RE: Review of South Heart Coal, LLC's Mining Permit SHSH-1001

# Review of South Heart Coal, LLC's Mining Permit SHSH-1001

Edward C. Murphy  
North Dakota Geological Survey

Figure 2. Geologic cross-section A-A' across the northern-most portion of the proposed South Heart coal mine.

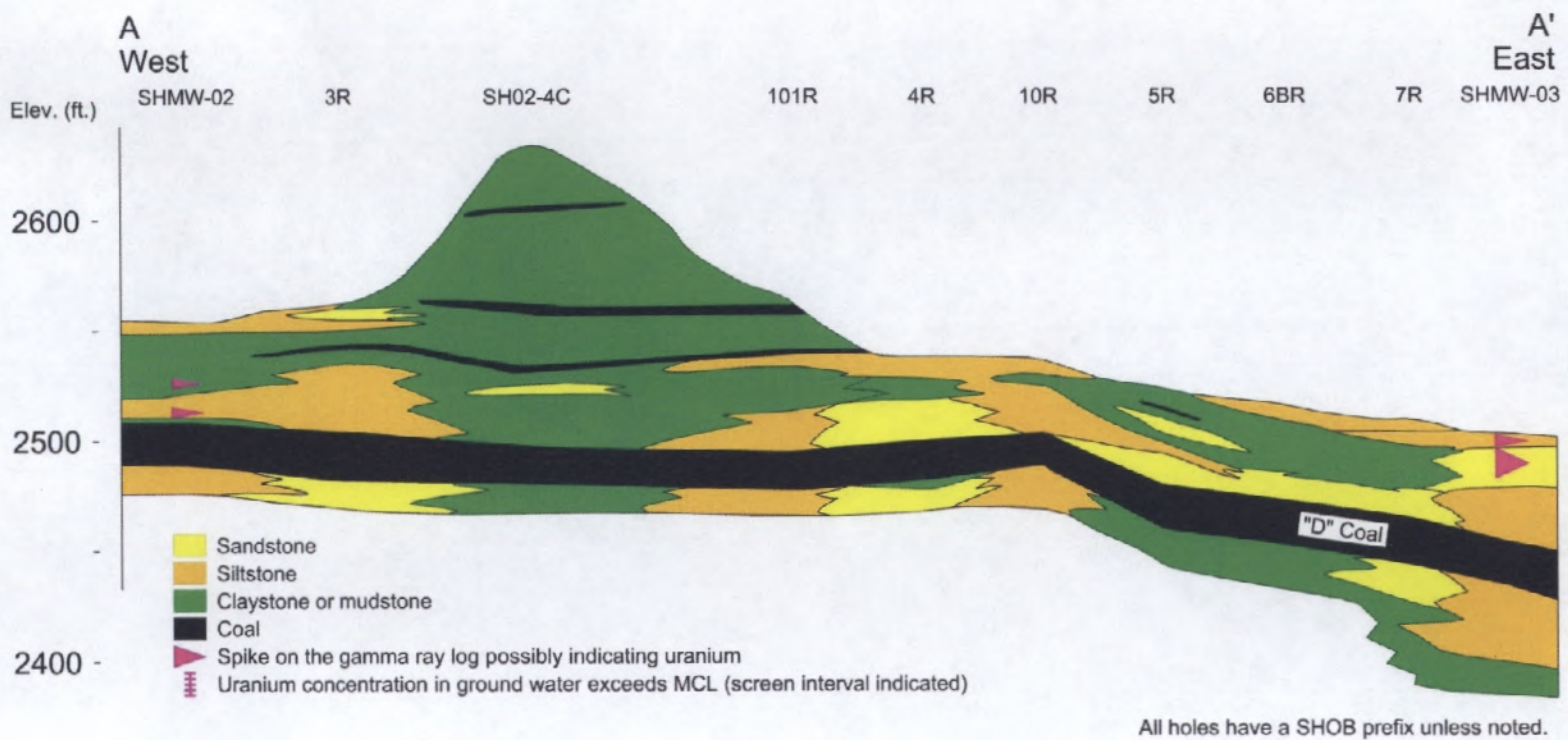
All five of the geologic cross-sections depict areas where the "D" coal is directly overlain by sandstone. Throughout southwestern North Dakota, the highest cps gamma spikes generally occur along sandstone/coal contacts (ie., where the coal is directly overlain by sandstone), at the base of sandstones where underlain by other lithologies, or in organic lenses within sandstones. The only gamma spike observed in close proximity to the "D" coal was in SHMW-02, where a small spike was observed near the base of a siltstone that was separated from the underlying "D" coal by a two-foot-thick claystone (Figure 2). There were no indications on the gamma ray logs of increased gamma counts within the "D" coal.

Figure 4. Geologic cross-section C-C' across the midpoint of the proposed South Heart coal mine.

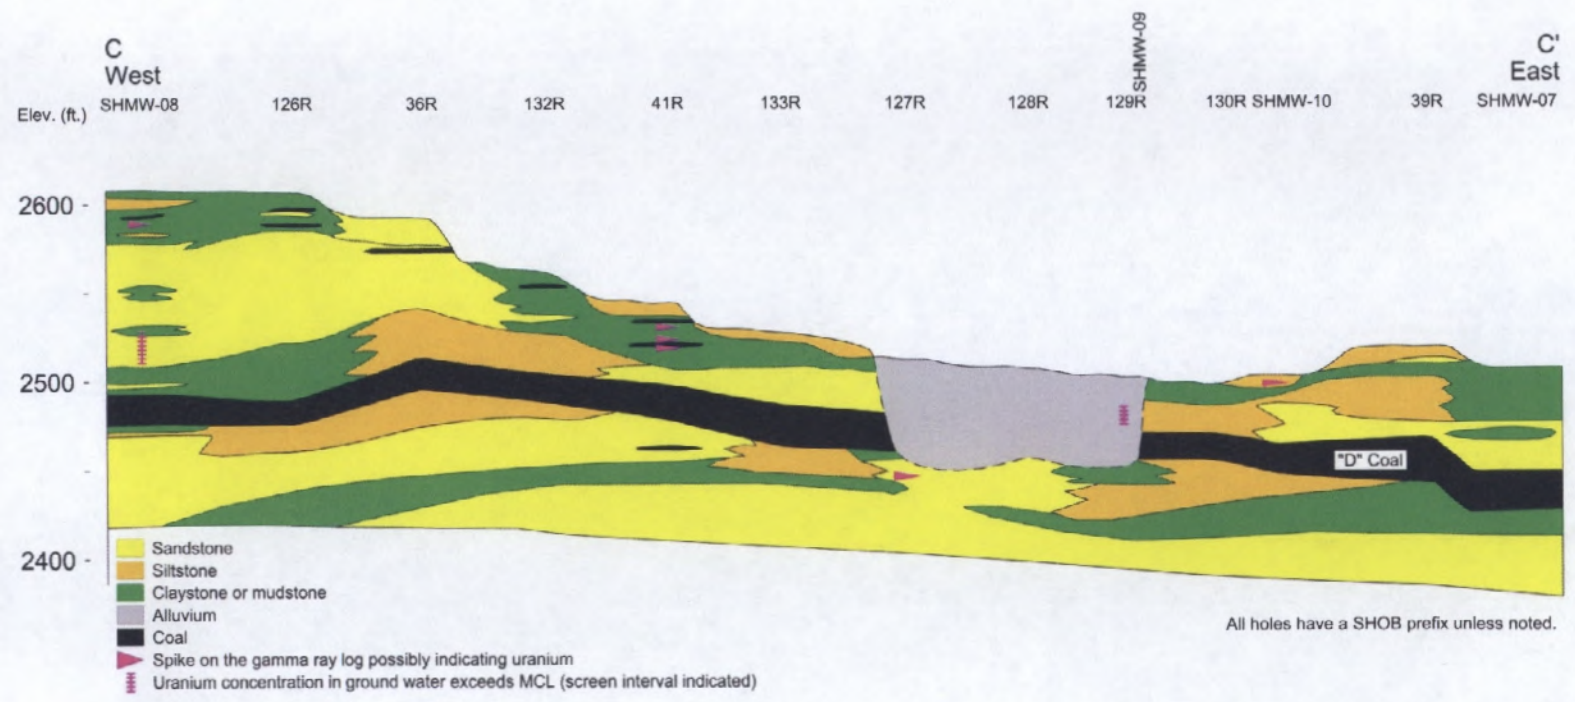
gamma spikes occurs in the overburden above the "D" coal (Figures 2-6). That gamma spike (530 cps in log number SHOB-127) occurs approximately 15 feet below the base of the "D" coal and, therefore, would not be disturbed by mining (Figure 4). The Sentinel Butte Formation sandstone that contains this gamma spike appears to be directly overlain, at least in some places, by an alluvial deposit of the South Branch of the Heart River. This alluvium is potentially the source of the uranium. The majority of the other gamma spikes occurred within 50 feet of the surface or what would be the upper part of the overburden if this area is mined (Figures 2-6).

The screen intervals for monitoring wells SHMW-08s, SHMW-09A2, and SHMW-14A1 were plotted on the geologic cross-sections (Figures 4 and 5). Monitoring wells SHMW-11A1 and SHMW-15A1 plotted outside of the cross-section areas (Figure 1). Monitoring well SHMW-09A2 contained an average uranium concentration of 67 ug/l, SHMW-14A1 an average of 28 ug/l, and SHMW-11 an average uranium concentration of 19 ug/l (Table 2). Wells SHMW-09A2 and SHMW-14A1, and possibly SHMW-11, appear to have been screened in alluvium (Figures 4 and 5). Of the five monitoring wells that contained uranium values in excess of the MCL, mining is only likely to occur in the vicinity of SHMW-08 (Figures 1 and 4). That monitoring well, screened at the base of a sandstone approximately 16 feet above the "D" coal, contained an average of 53 ug/l of uranium (Figure 4).

Figure 5. Geologic cross-section D-D' across the proposed South Heart coal mine.

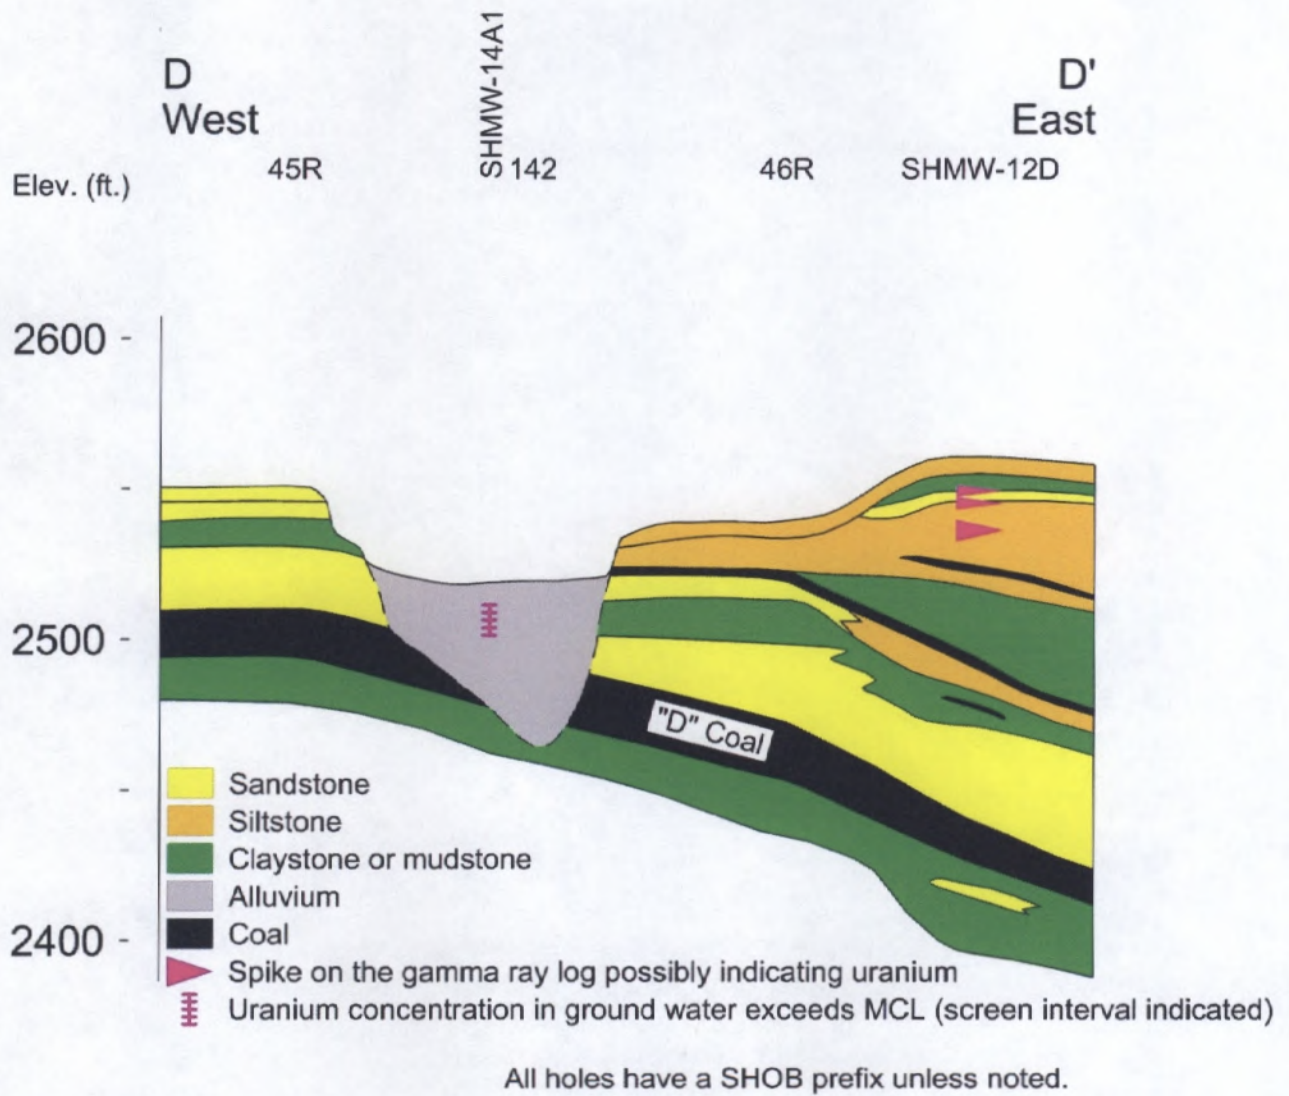
Great Northern Project Development L.P. installed 32 monitoring wells in and around the proposed mine site and tested for a number of major ions and metals including uranium. The maximum contaminant level (MCL) for uranium in drinking water is 30 micrograms per liter (ug/l). The uranium concentrations in the Great Northern water samples were reported in milligrams per liter, but were converted to micrograms per liter for Table 2 and North Dakota Geological Survey Geologic Investigations No. 139. While groundwater within the majority of the Great Northern monitoring wells contained less than 1 ug/l of uranium, five monitoring wells contained at least one water sample that exceeded the MCL for uranium (Table 2). Four of those monitoring wells are very shallow, less than 25 feet deep. Of the five wells, one is located more than one mile northeast of the proposed mine boundary (SHMW-15A1) and two others are on the southwestern edge of the proposed mine boundary (SHMW-08 and SHMW-11A2) (Figure 1). The average uranium concentrations (obtained after discarding the high and low analysis) exceeded the MCL in two of these monitoring wells (SHMW-09A2 and SHMW-08S) and were just below the MCL in a third well (SHMW-14A1). The maximum uranium concentrations in these wells ranged from 44-93 ug/l. Monitoring wells SHMW-09A2 and SHMW-14A1 are in alluvium in areas where the "D" coal has been removed by erosion, so those areas would not be mined (Figures 4 and 5).
